City of Detroit
Inter-Departmental Communication

RE: Petition No. 1821-revised
Request to Outright Vacate Various Streets And Alleys And Encroachment Into Monroe
And A Portion Of Cadillac Square In The Area Bound By Monroe, Randolph, Bates, And
Cadillac Square

NOTICE OF PROPOSED CHANGE IN PROPERTY

REQUEST TO OUTHRIGHT VACATE
 VARIOUS PUBLIC STREETS AND ALLEYS AND
 REQUEST ENCROACHMENT OF
 BATES ST. AND A PORTION OF MONROE AVE. AND CADILLAC SQ.
 IN THE AREA BOUND BY
 MONROE AVE., RANDOLPH AND BATES ST.
 AND CADILLAC SQUARE

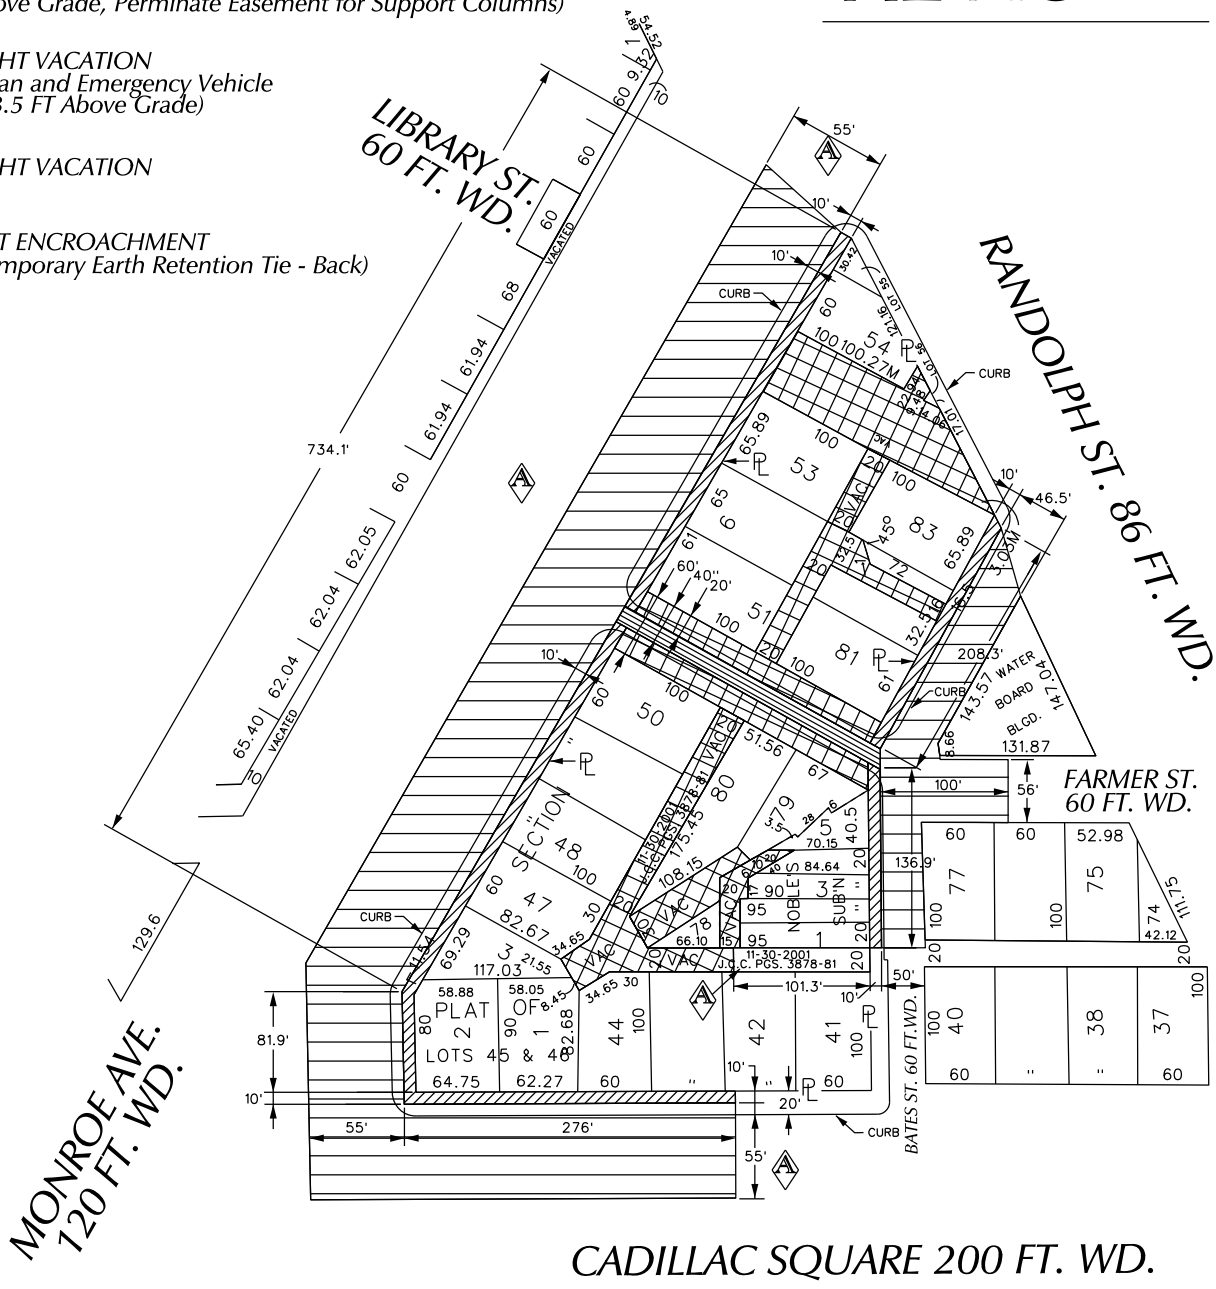
B					
A	REDUCING THE TEMPORARY EARTH RETENTION TIE BACK REMOVE THE REQUEST TO VACATE ALLEY AND REMOVE THE UNDERGROUND RAMP AND TUNNEL	WLW	KSM	KSM	7/27/18
REVISIONS					
DESCRIPTION	DRWN	CHKD	APPD	DATE	
	WLW		KSM		
DATE	APPROVED				
04-03-18

- Remove the proposed underground Monroe ramp and tunnel.
- Remove the request to vacate and retaining the utility easement for the section of the alley behind the Cadillac Tower, this will remain public right-of-way.
- Reduce the temporary earth retention tie back encroachment extents from 100 feet to between 55 feet and 46.5 feet.

PETITION 1821
 MONROE BLOCK VACATIONS
 REVISED 1/31/2018

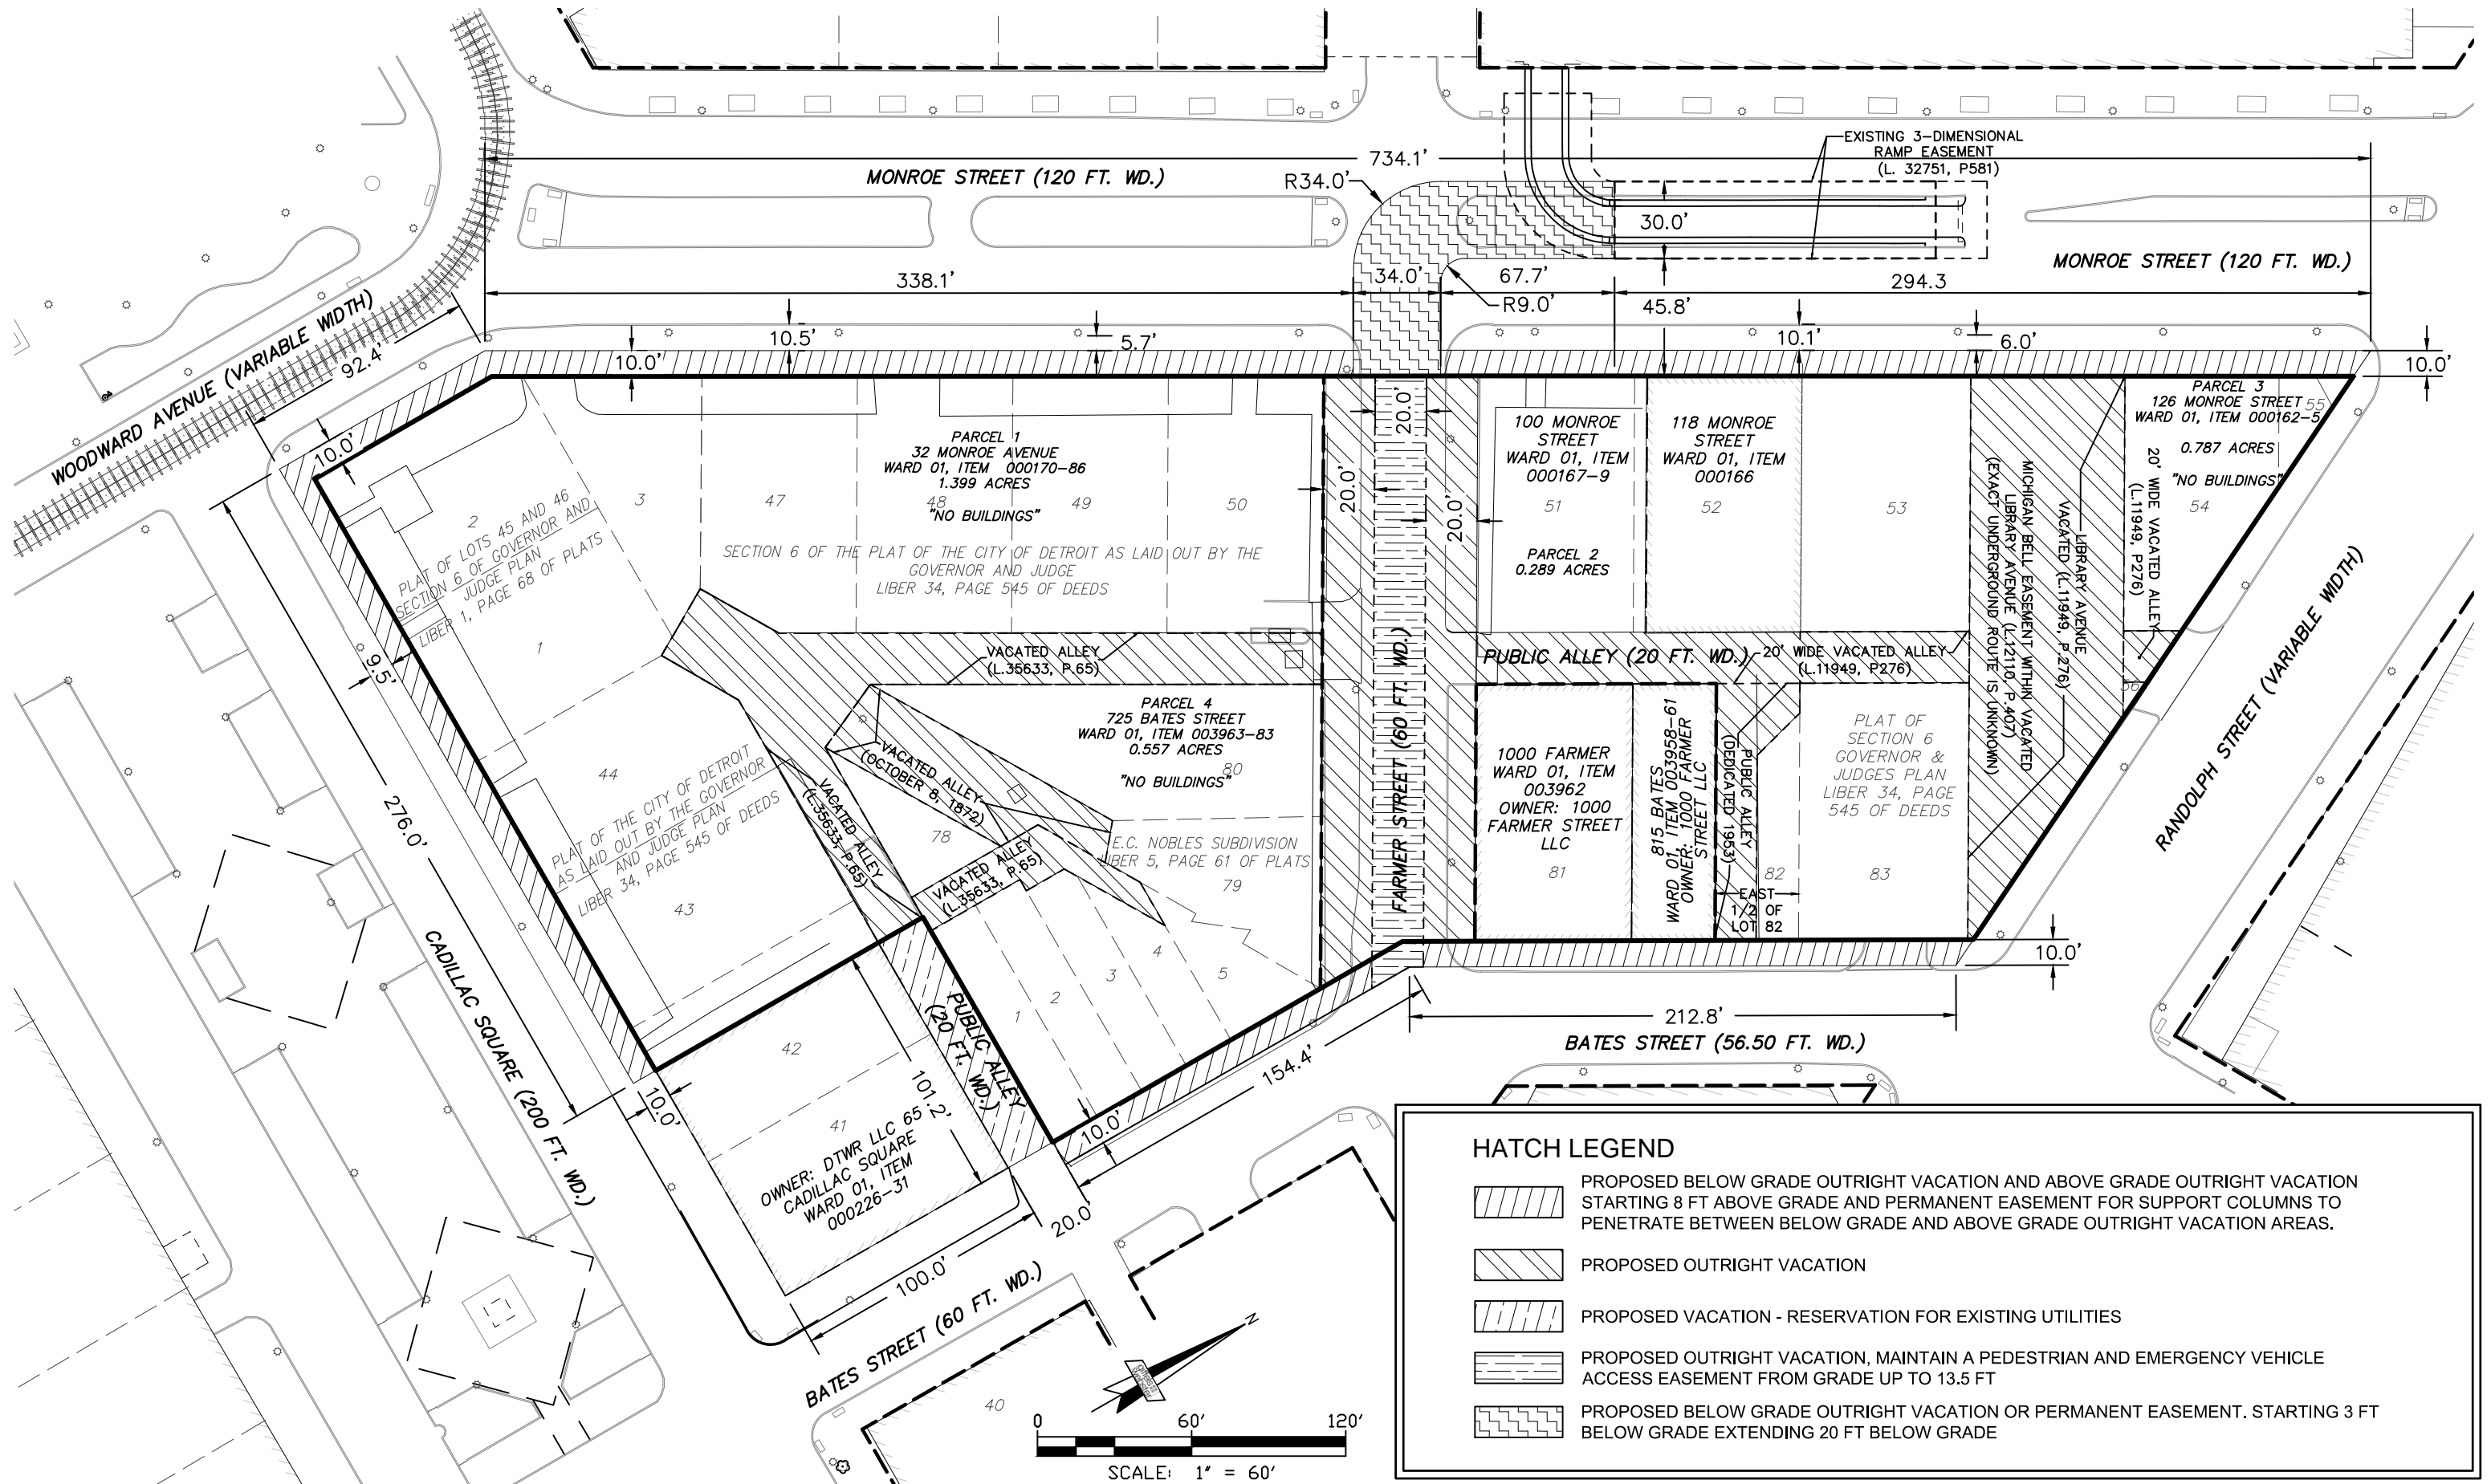
Page1: The revised configuration of the Monroe ramp/tunnel encroachment to line up with Farmer

Page2: We added the 2D extents of the temporary tie-back encroachments
